## **TENDER NO: 2024-17**

# <u>Lower Cove Loop –</u>

## **CSO Chamber Rehab & Check Valve Installation**

### **ADDENDUM**

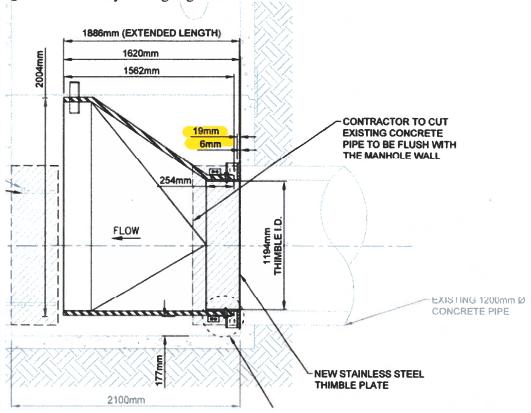
Q2: Please clarify the highlighted dimensions

**A2:** 6mm represents the gasket and 19mm represents the plate thickness. This is based on a shop drawing from the valve supplier for the thimble plate.

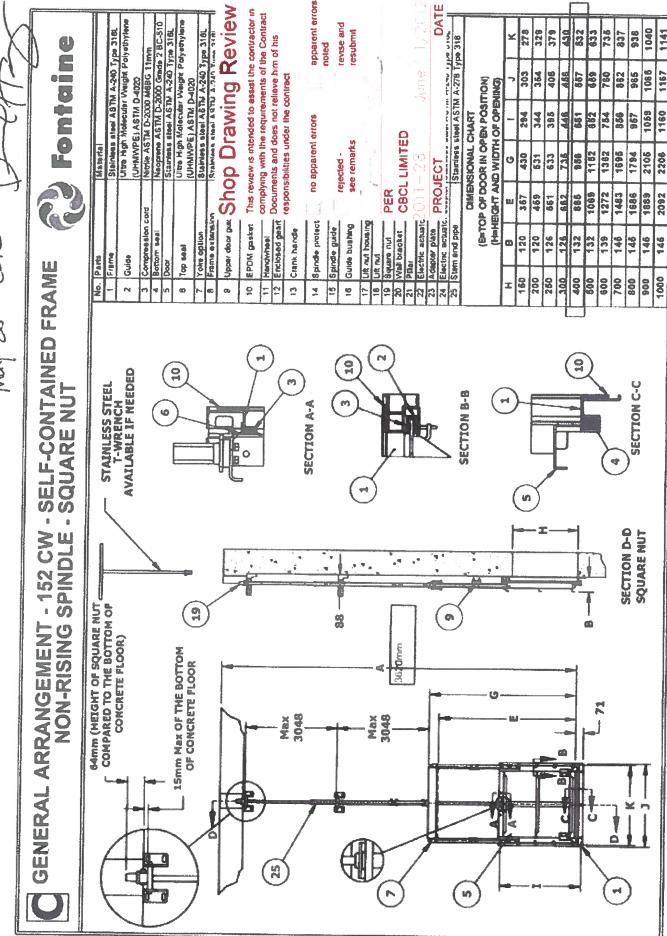
**Q6:** The supplier of the sluice/slide gate is requesting additional information, is there a shop/fab drawing for the existing at the time of installation? They were asking for a dimensioned drawing related to the area/opening where the gate is to be installed.

**A6:** Please find the attached shop drawing of the existing sluice/slide gate providing dimensions.
